STAFF REPORT
COMMUNITY DEVELOPMENT DEPARTMENT

HEARING DATE: 11/17/2020
TO: Mayor & City Council
FROM: Joe Dodson, Associate Planner
208-884-5533
SUBJECT: H-2020-0060
Horse Meadows Subdivision
LOCATION: The site is located at 710 N. Black Cat, in the NW ¼ of the NW ¼ of Section 10, Township 3N., Range 1W.

Rezone of 5.33 acres of land from the R-4 zoning district to the R-8 zoning district and preliminary plat consisting of 26 single-family residential lots and 4 common lots on 4.71 acres, by Riley Planning Services.

B. Preliminary Plat (date: ~~9/1/2020~~ 9/16/2020 11/12/20)

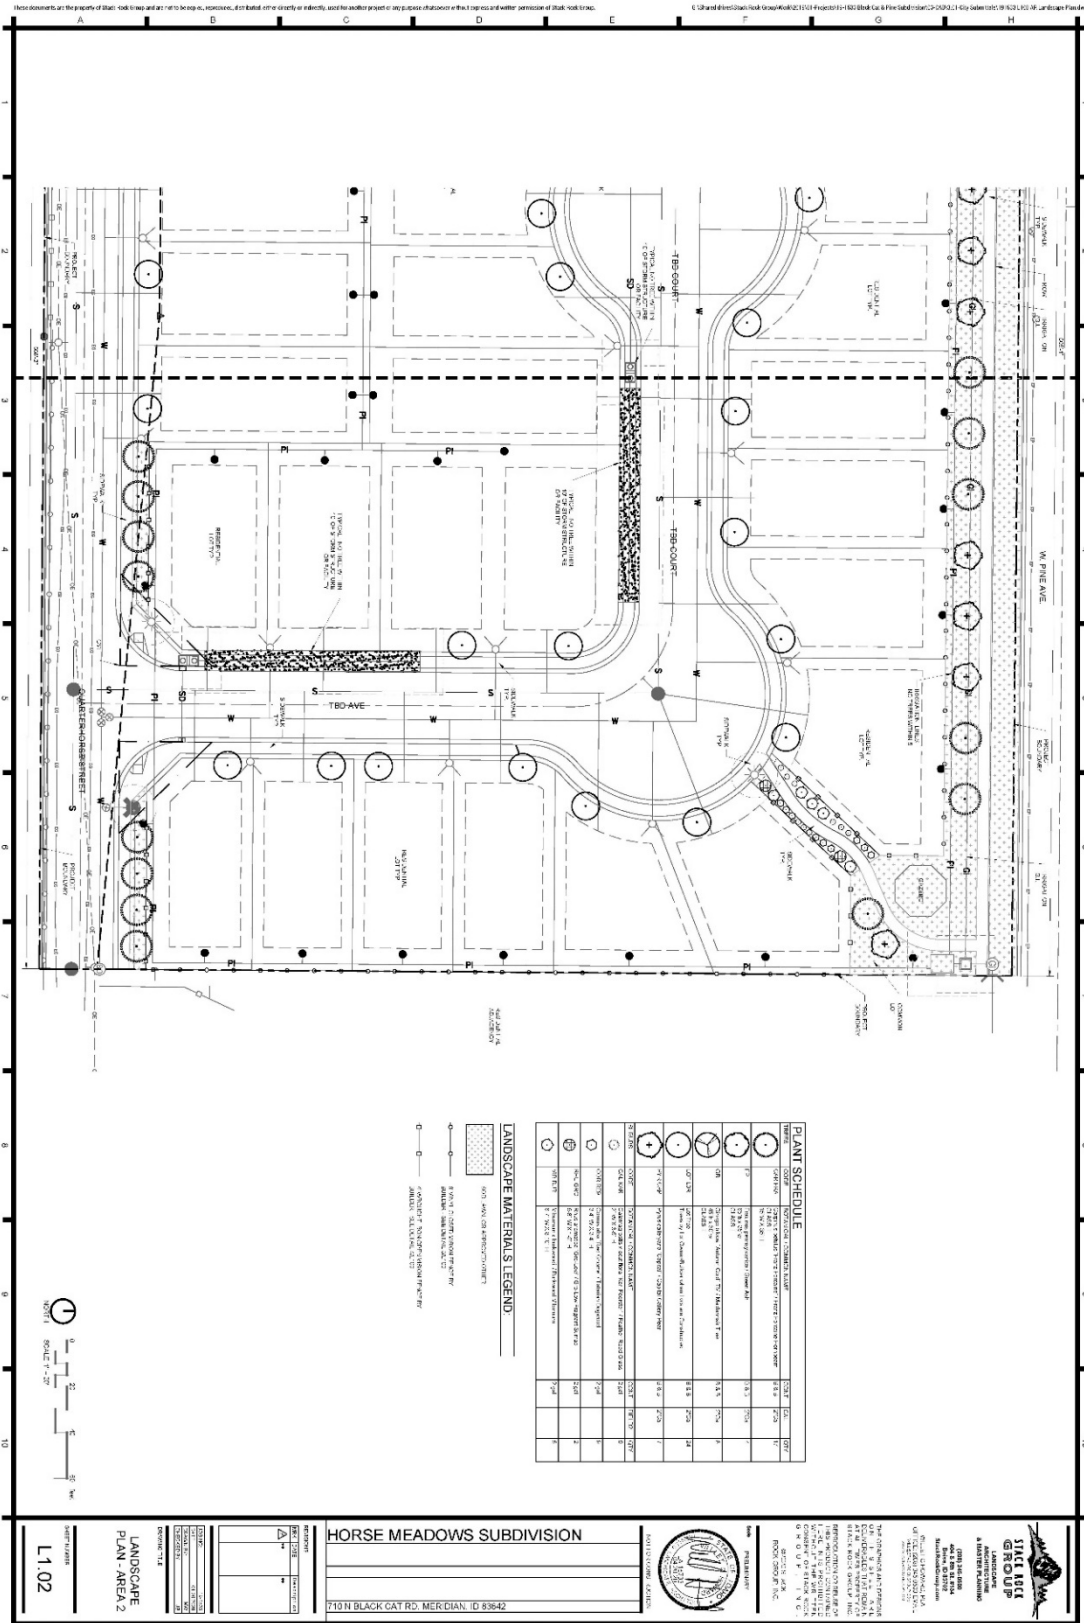
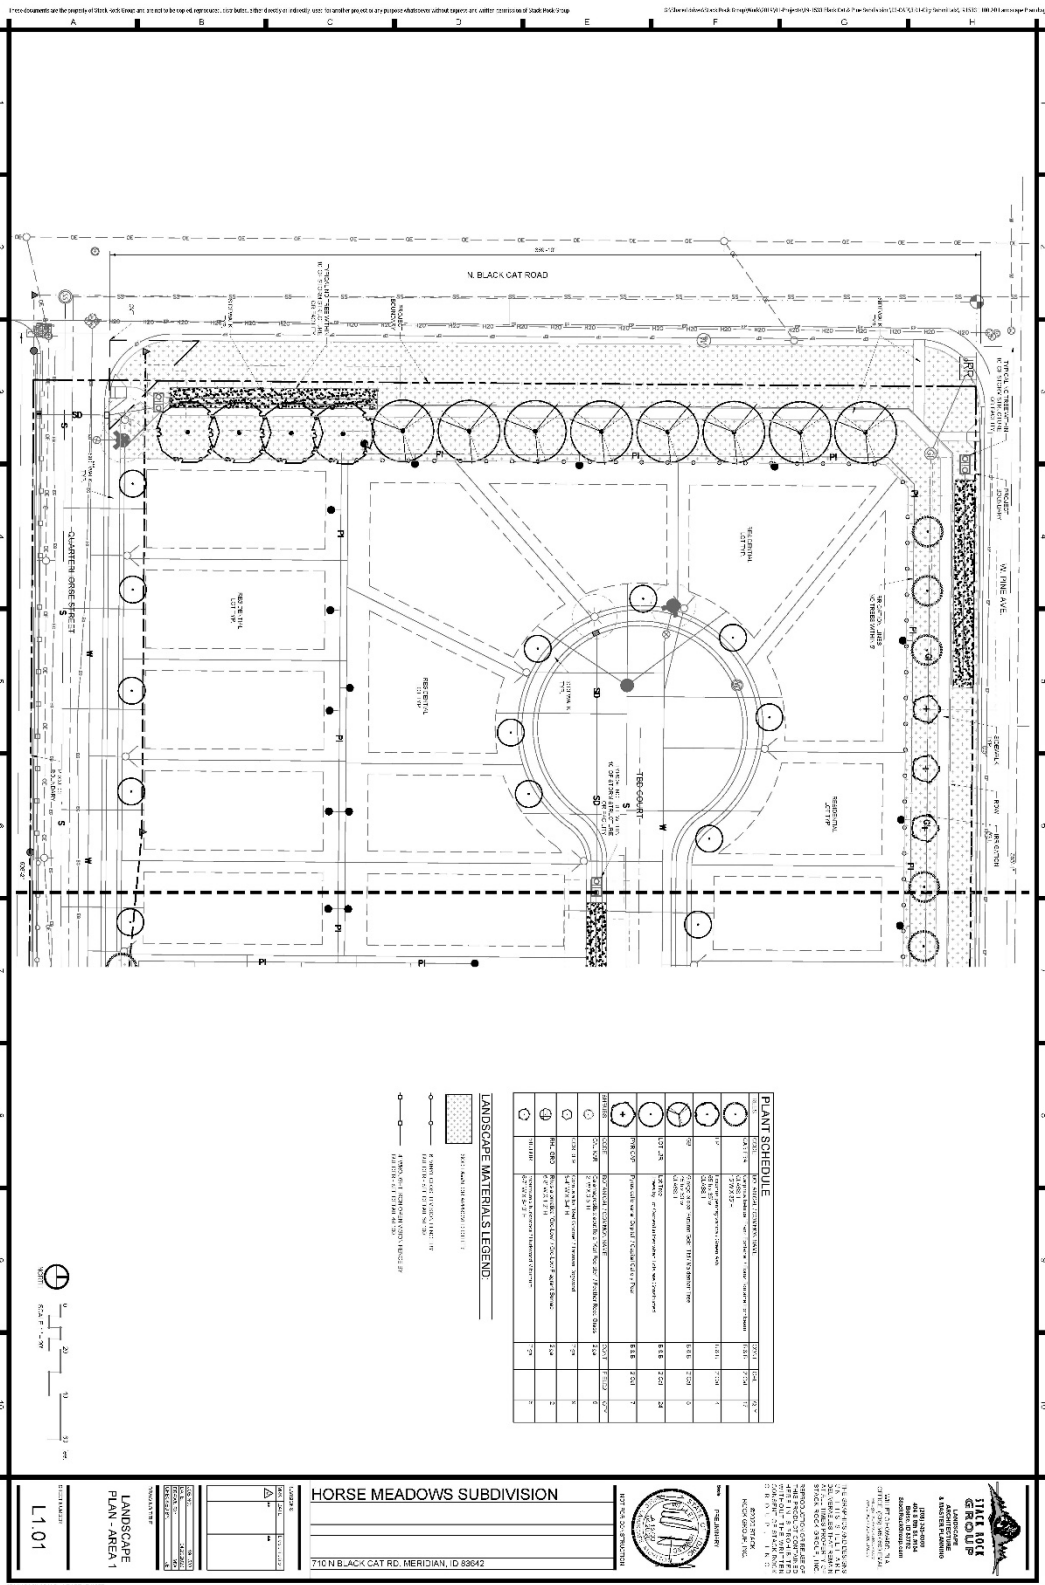
2. ~~At least ten (10) days prior to the City Council hearing~~ Prior to Final Plat submittal, the preliminary plat included in Section VII.B, dated ~~09/01/2020~~ 11/12/2020, shall be revised as follows:

- ~~a. Add a note prohibiting direct lot access via N. Black Cat Road.~~
 - b. Revise the plat to show the detached sidewalks along N. Black Cat Road and W. Pine Avenue with at least 4 feet of separation between it and the ultimate ACHD right-of-way.

- c. ~~Add a~~ Revise plat note number 18 regarding stating that Lot ~~9~~10, Block 1 to state: Lot 10, Block 1 is a non-buildable lot and is to be owned and maintained by the HOA until such time that it redevelops as either common open space or as public right-of-way only.
